JLR No.: 25205-100.1  
Revision: 3

June 30, 2020

# Site Servicing Report Addendum

## 99 Parkdale Avenue

Drawing S1 (June 24, 2020)

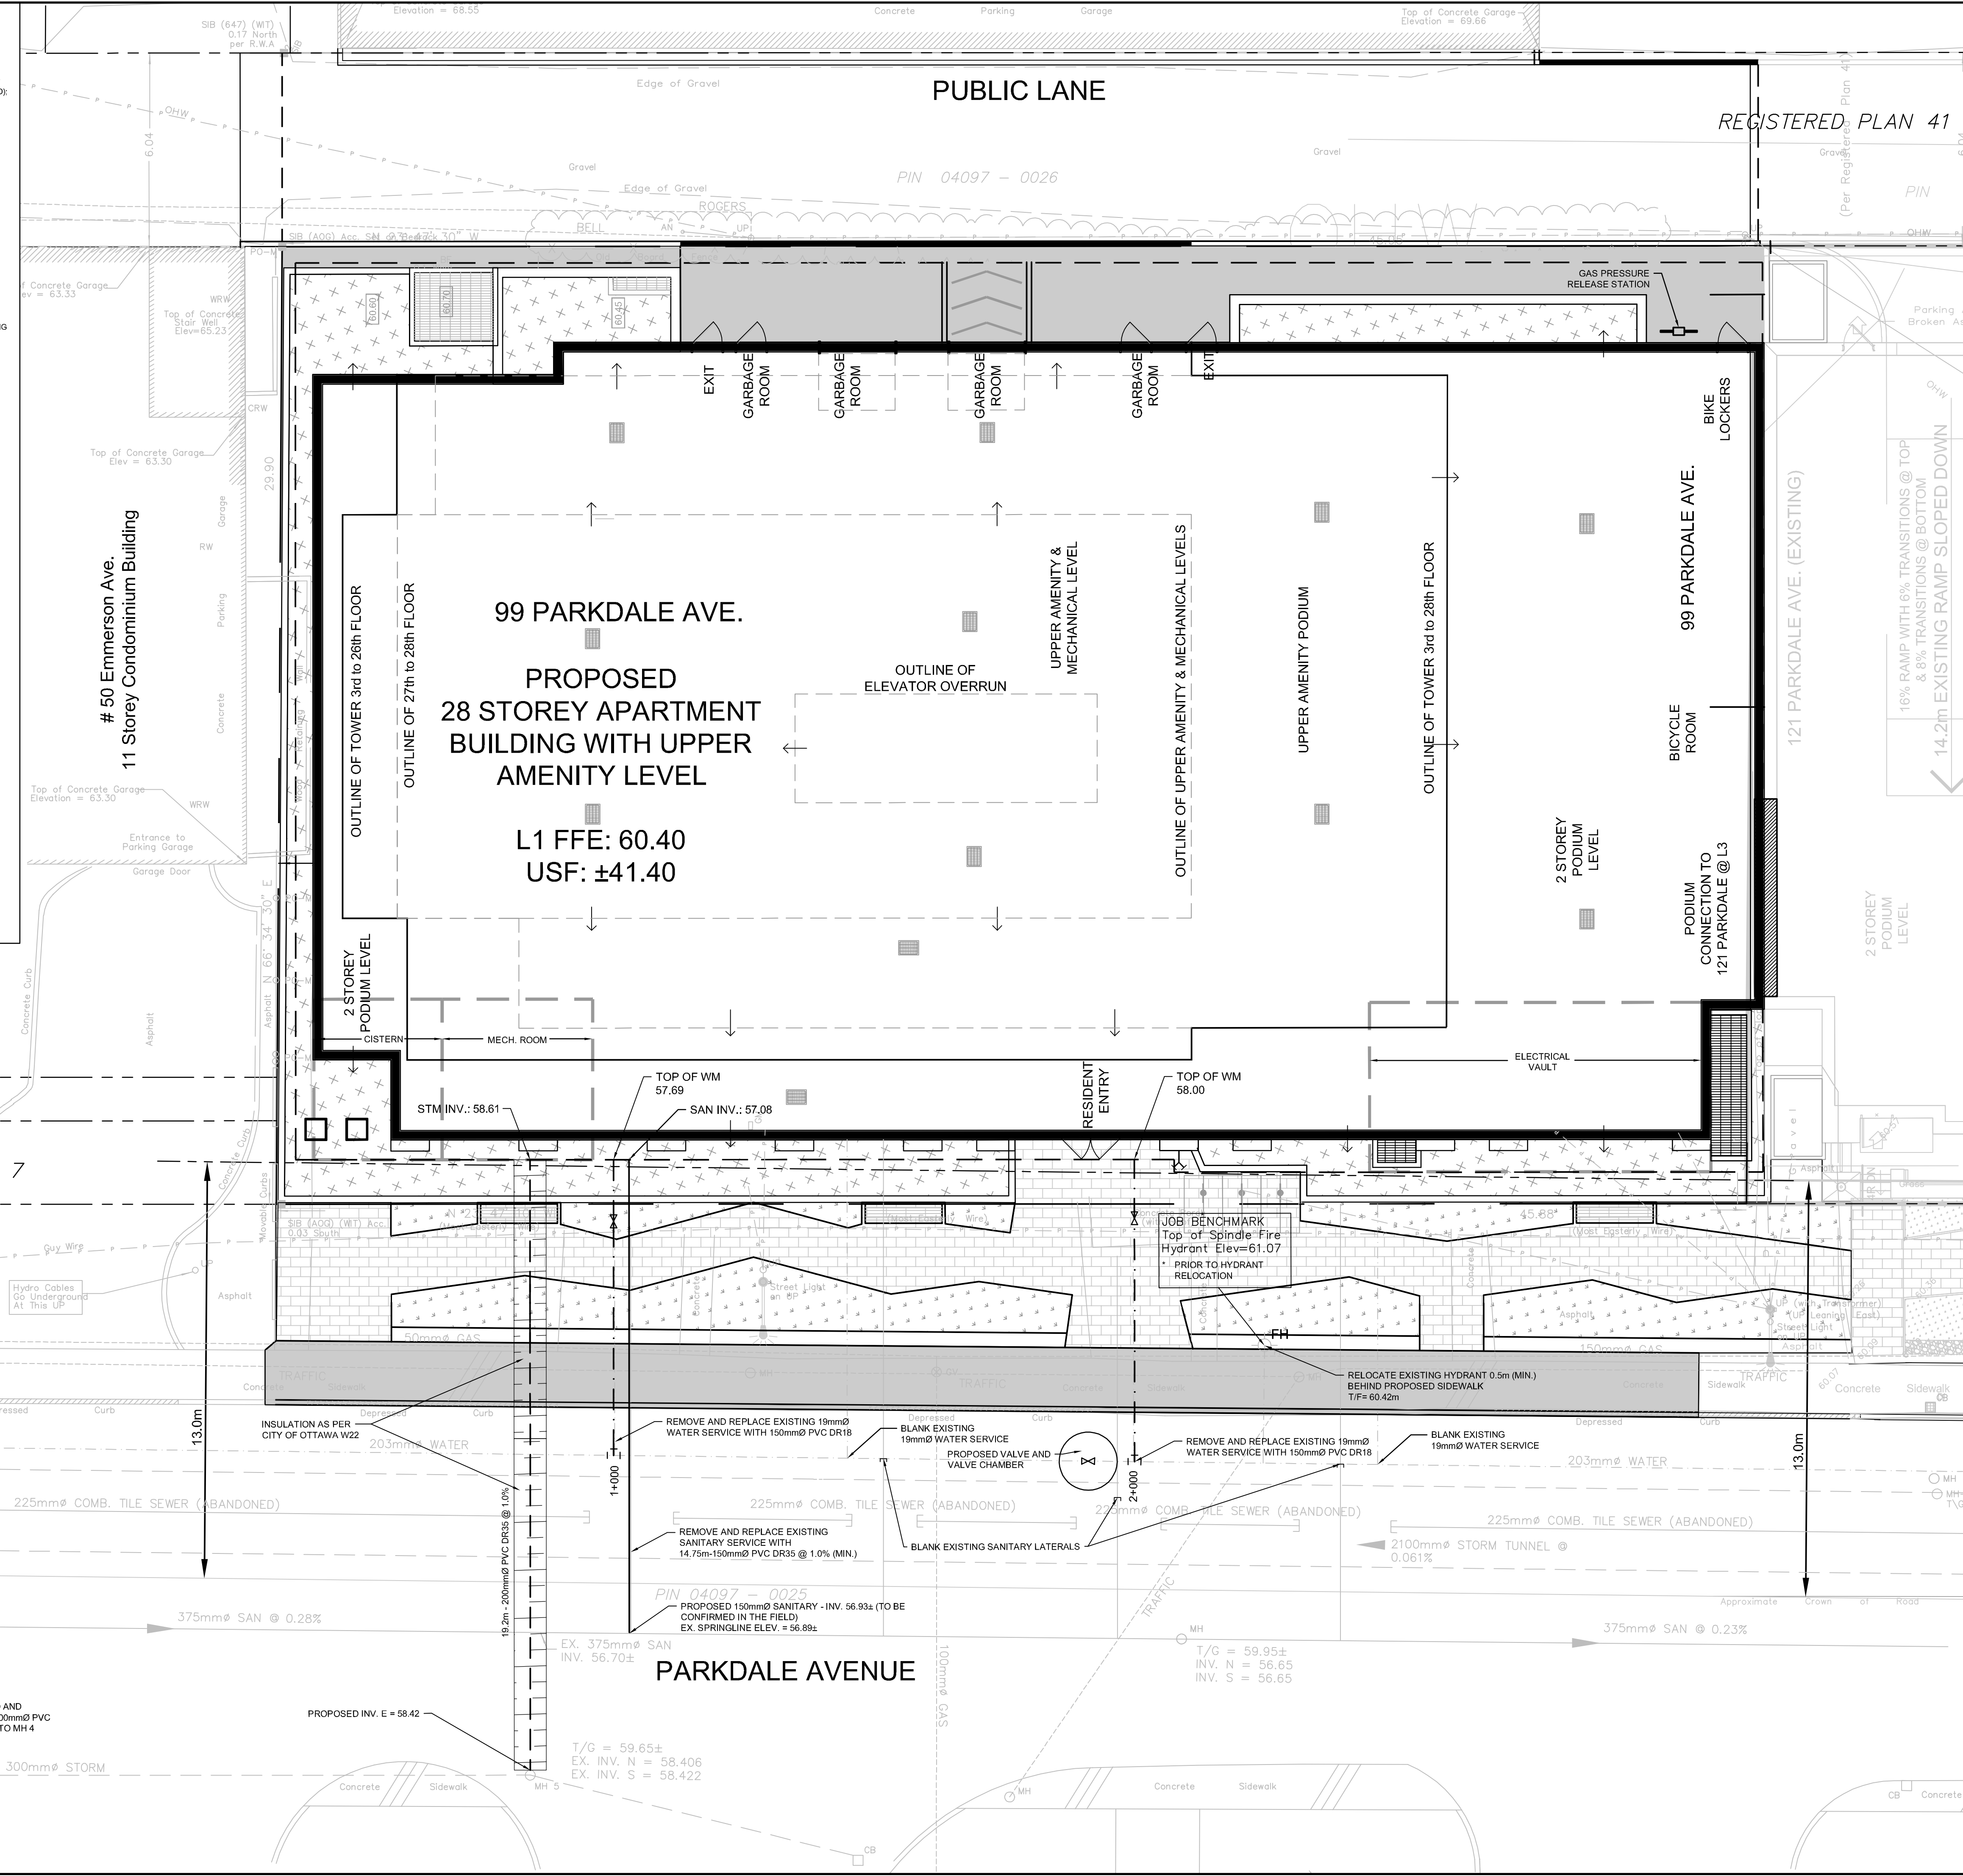
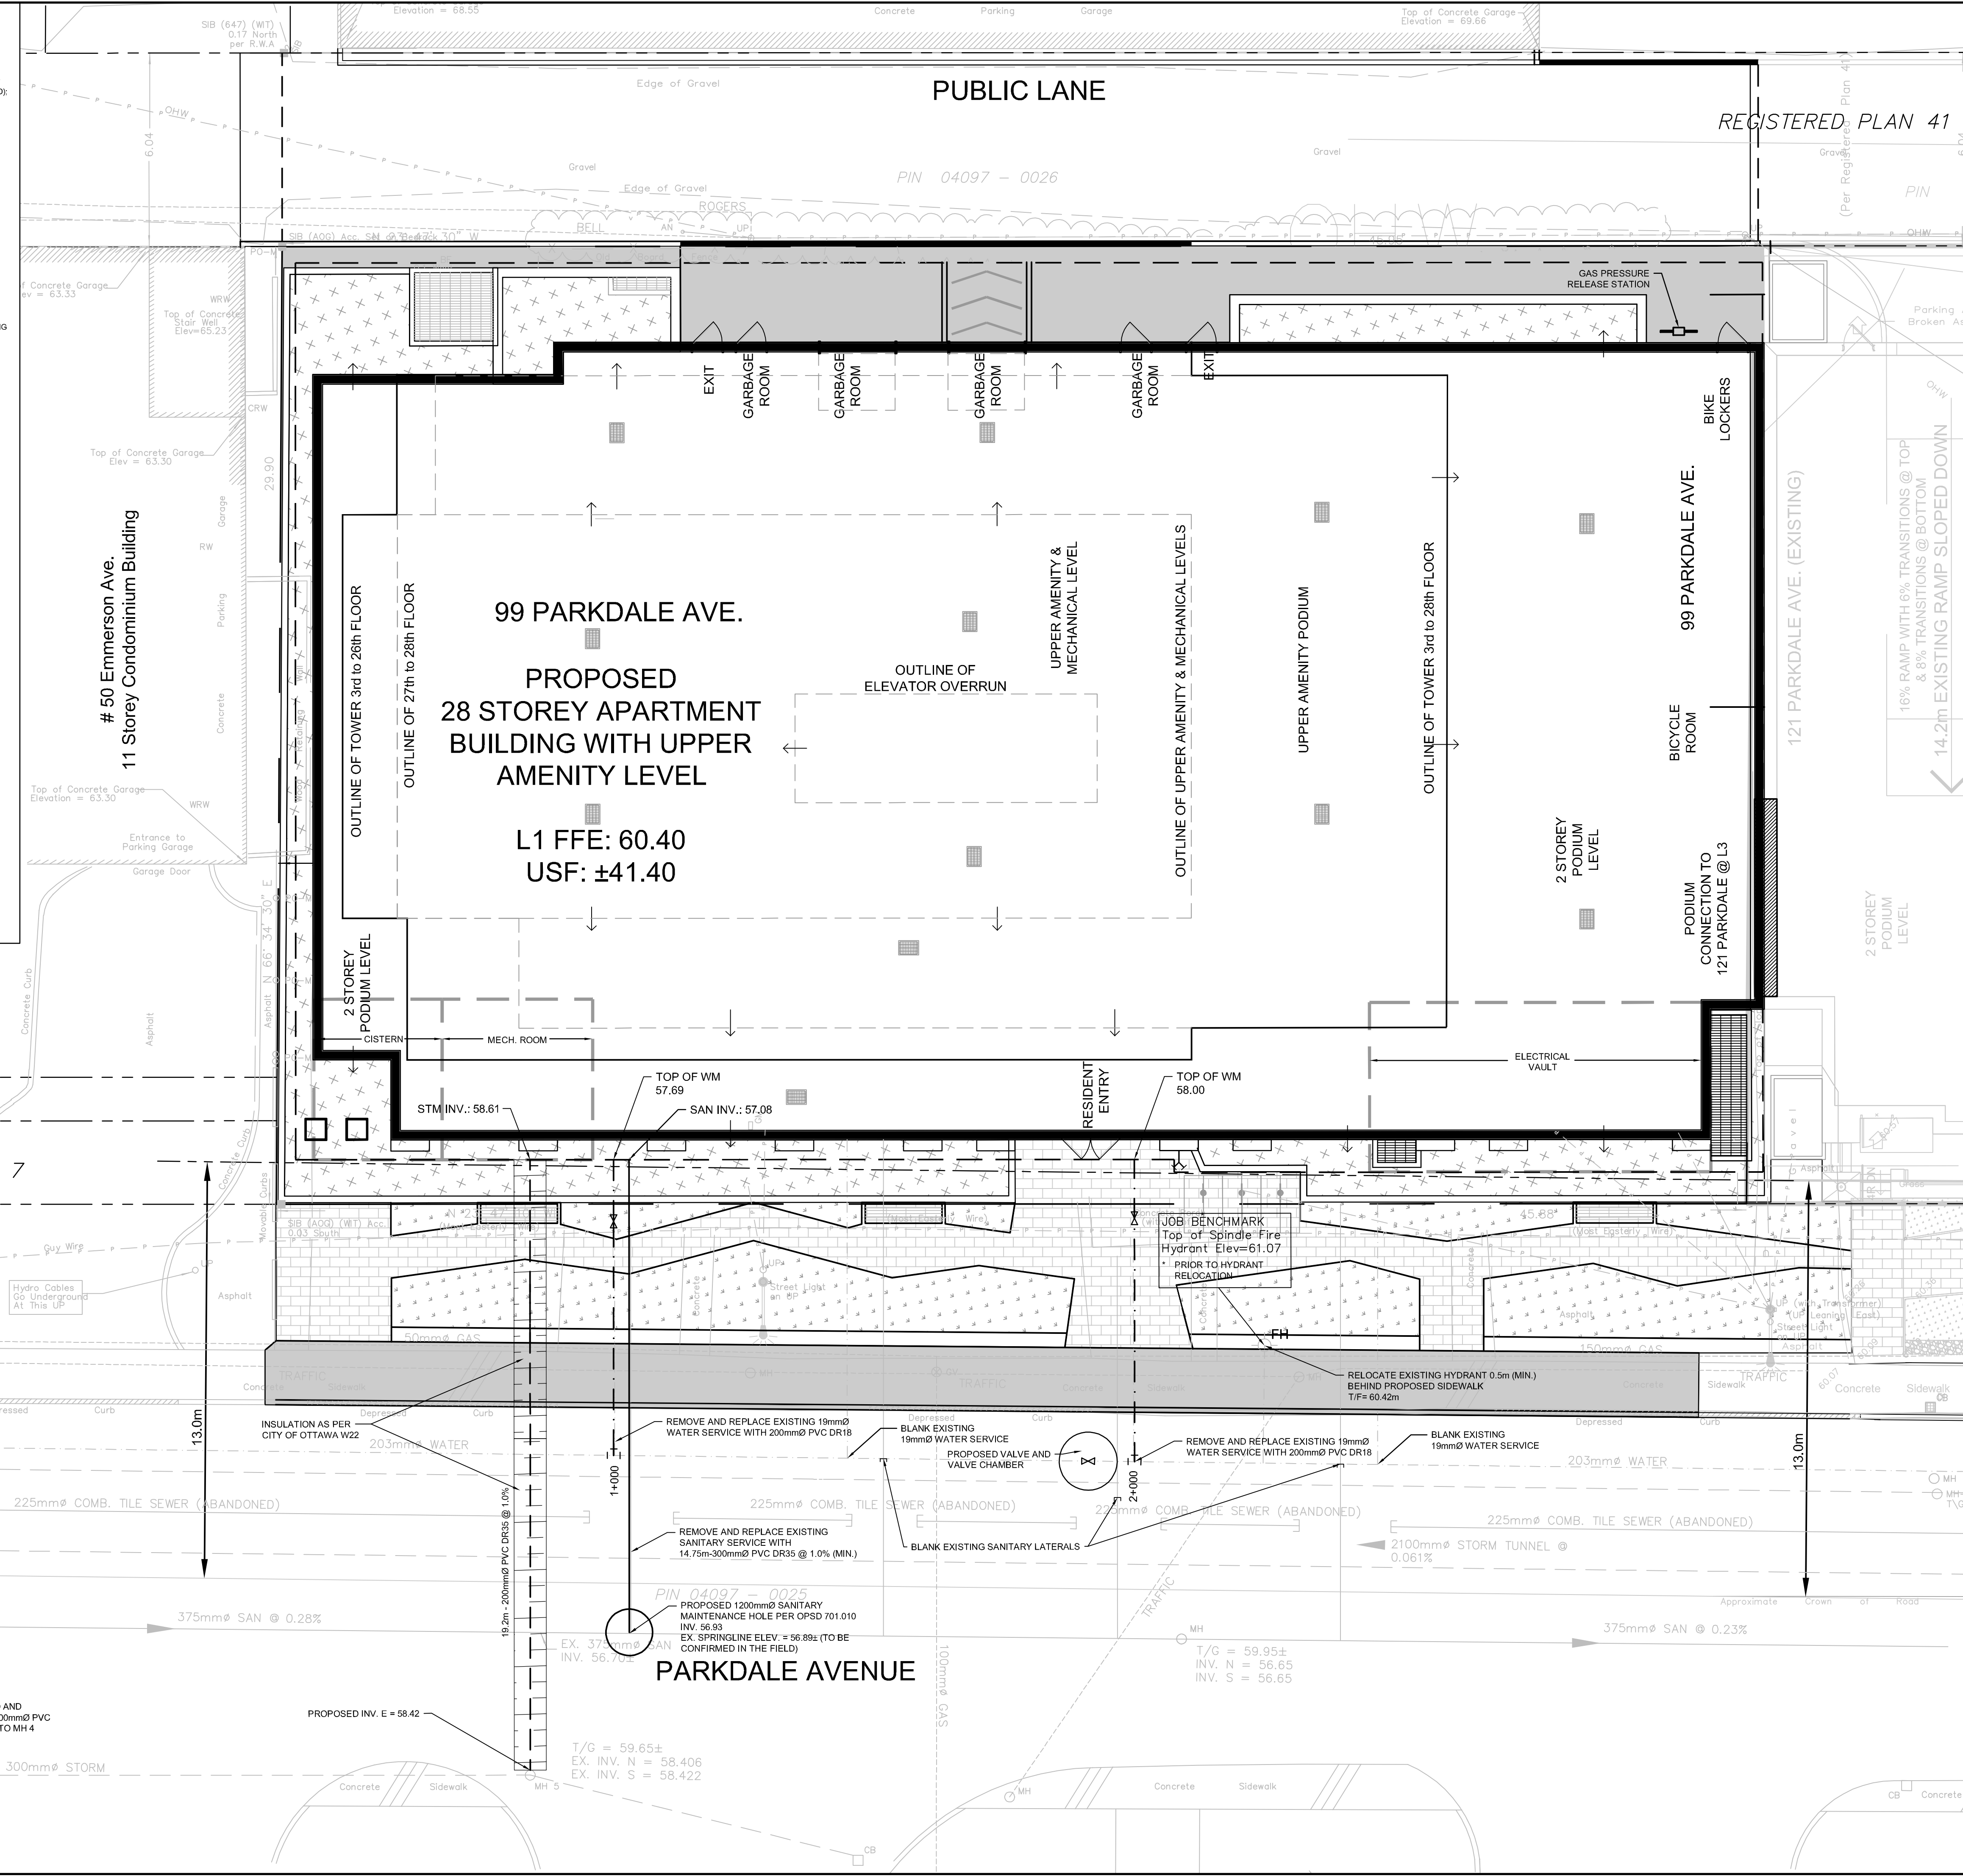
Due to the building size, the OBC requires that water servicing consists of a 200 mm diameter watermain for the purpose of fire protection. Given the requirement for watermain reliability, the approved twin 150 mm diameter watermains (refer to Appendix A) are proposed to be revised to twin 200 mm diameter watermains as depicted on the revised Servicing Drawing (refer to Appendix B for copy of revised S1, dated June 24, 2020).

Due to the building size, the OBC requires that wastewater servicing consists of a 300 mm diameter sanitary sewer. Consequently, the approved 150 mm diameter sanitary sewer (refer to Appendix A) is proposed to be revised to a 300 mm diameter sanitary sewer as depicted on the revised Servicing Drawing (refer to Appendix B for copy of revised S1, dated June 24, 2020). Given the larger sanitary sewer size, a maintenance hole is now being proposed to be constructed at the connection point with the existing 375 mm diameter sanitary sewer as the proposed sewer size is greater than 50% of the diameter of the mainline concrete pipe. The revised Servicing Drawing (Drawing S1) included in Appendix B shows the proposed manhole addition.

No.	ISSUE / REVISION	DD/MM/YY
05	REVISED LATERAL SIZES ISSUED FOR CITY STAMP	24/06/2020
04	RE-ISSUED PER REVISED SITE PLAN - FIFTH SUBMISSION	06/05/2020
03	ISSUED TO CITY FOR REVIEW - THIRD SUBMISSION	13/03/2020
02	ISSUED TO CITY FOR REVIEW - SECOND SUBMISSION	07/02/2020
01	ISSUED TO CITY FOR REVIEW - FIRST SUBMISSION	22/10/2019
